Subject: Lodi Energy Center (08-AFC-10)
Data Response Set 1C, Responses to CEC Staff Data Requests 52 and 56

Data Responses, Set 1C
(Responses to Data Requests 52 and 56)

LODI ENERGY CENTER

FIGURE DR56-1
PARCEL ADJACENT TO GAS LINE
LODI ENERGY CENTER
LODI, CALIFORNIA

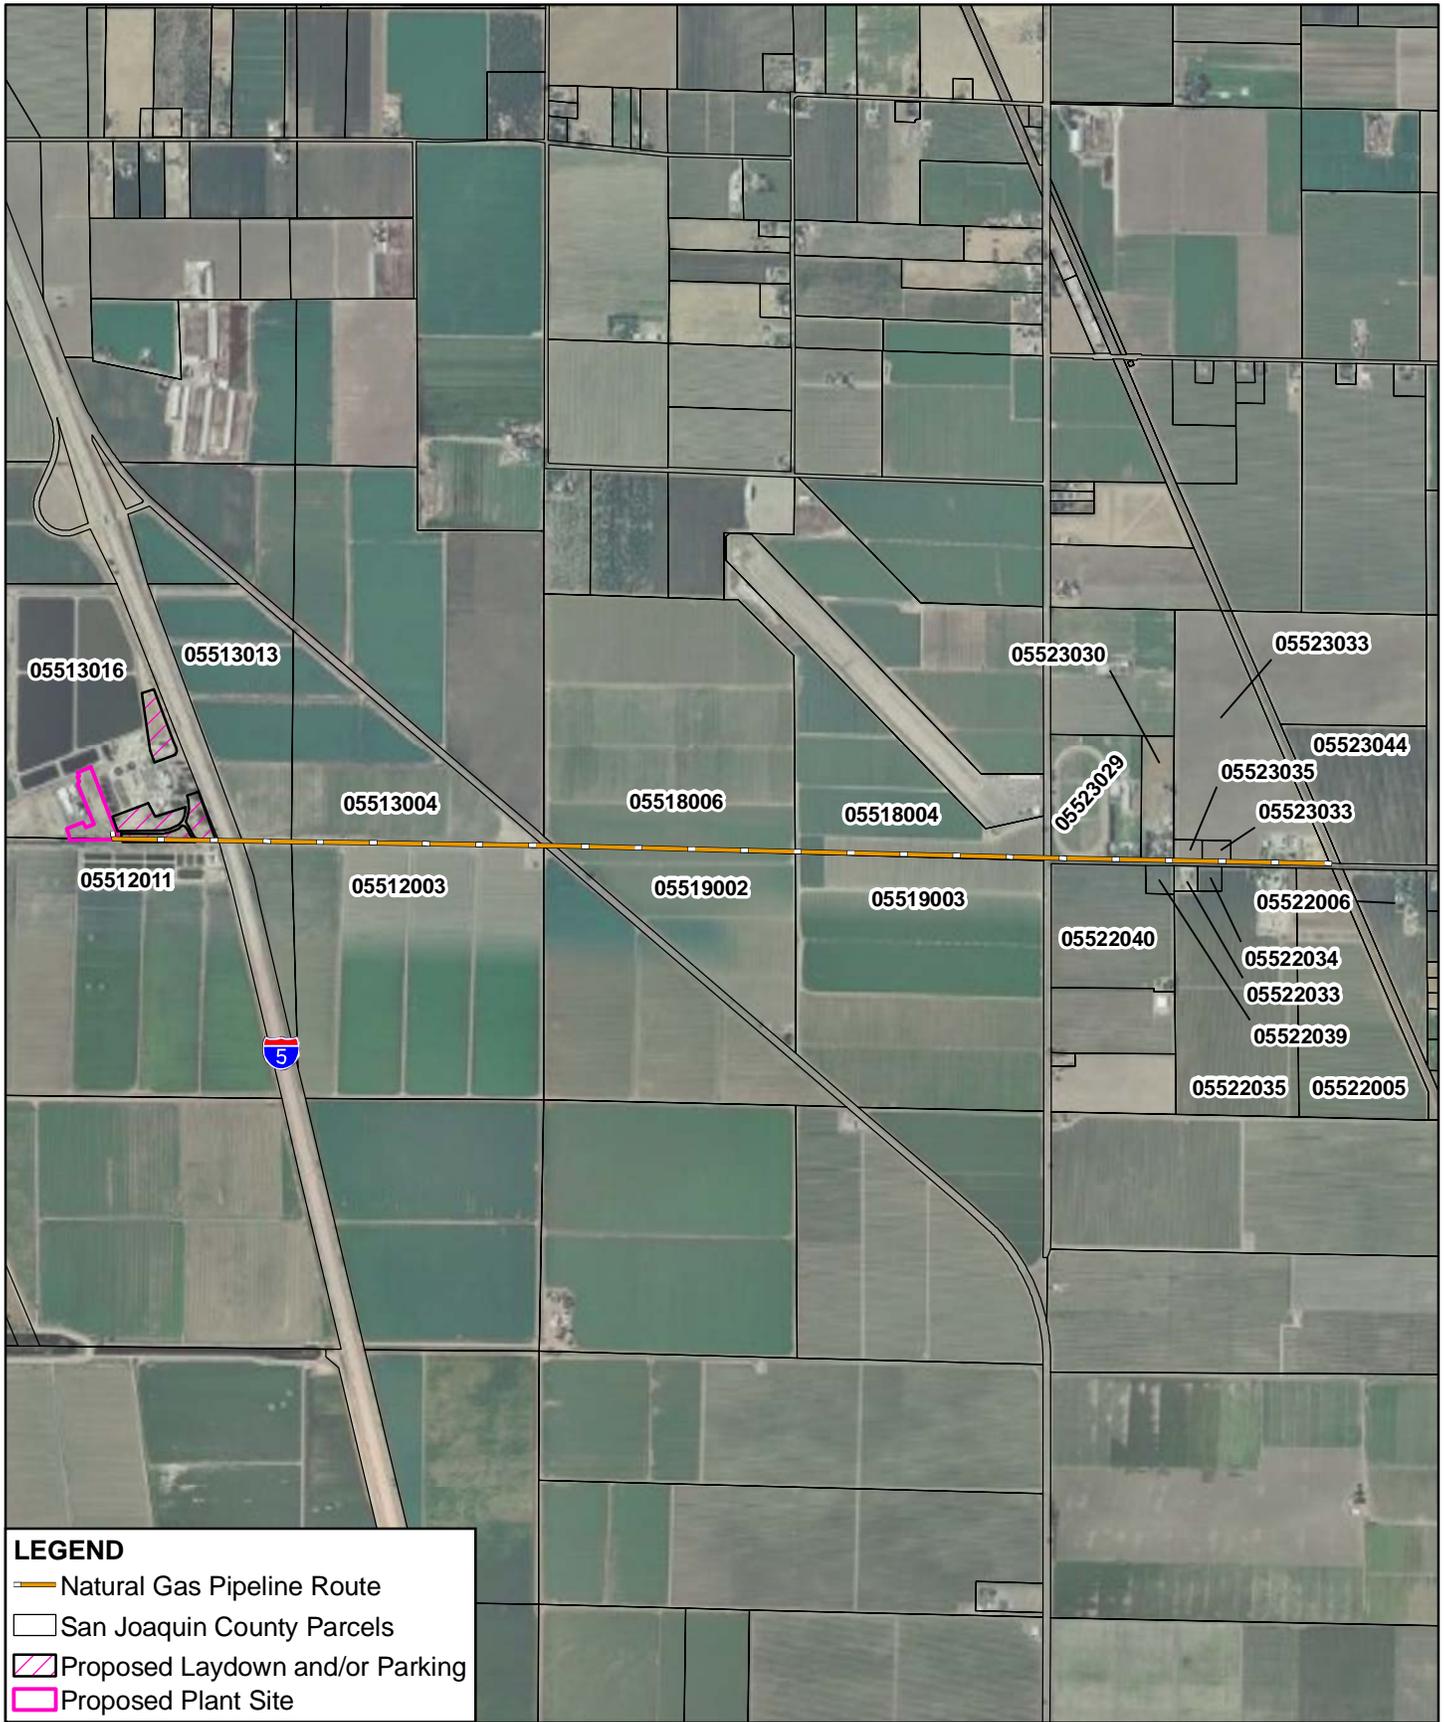
56. Please identify the type of crops grown over as long a period as records indicate, the historical use and identity of pesticides (including organic and inorganic pesticides as well as herbicides), and a statement of the likelihood of finding levels of pesticides along the pipeline/transmission route that might present a risk to pipeline workers and/or the public.

Response: Current crops along the gas line route include hay, alfalfa, and a small area of vineyards. The San Joaquin County Agricultural Commission has provided a list of historical crops and pesticide use along the gas line route, which is provided as Attachment DR56-1.
